Bulletin

Application: Allison MD3000 Series

Subject: Suction Filter Gasket

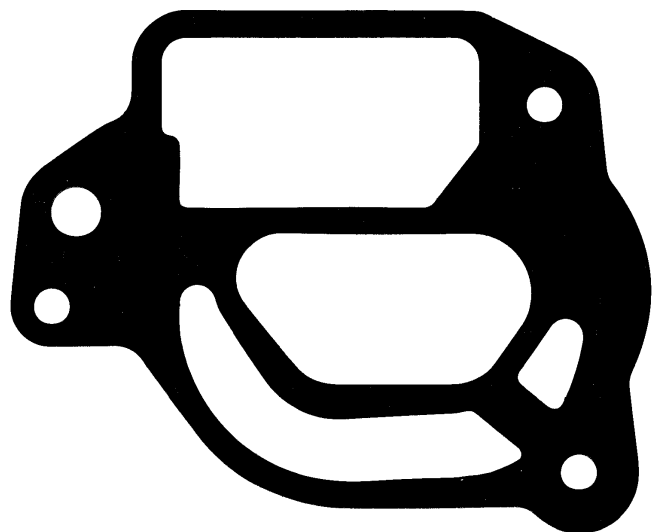
Allison changed the suction filter and suction filter housing for the MD3000 series transmission. The new filter/housing is now a one-piece design, as opposed to the previous two-piece design. This “late” one-piece filter housing requires a new design gasket. The new gasket, TransTec #12289 (OEM #29537066) , will retrofit back provided that the “late” one-piece filter housing is used.

EARLY – Used with two-piece filter housing assembly.

LATE – Used with one-piece filter housing assembly.

The late, one-piece filter housing assembly can be ordered from Allison under OEM #29537067.

All TransTec valve body kits for the MD3000 series with a date code of B02 and later contain both the early and the late design gaskets.
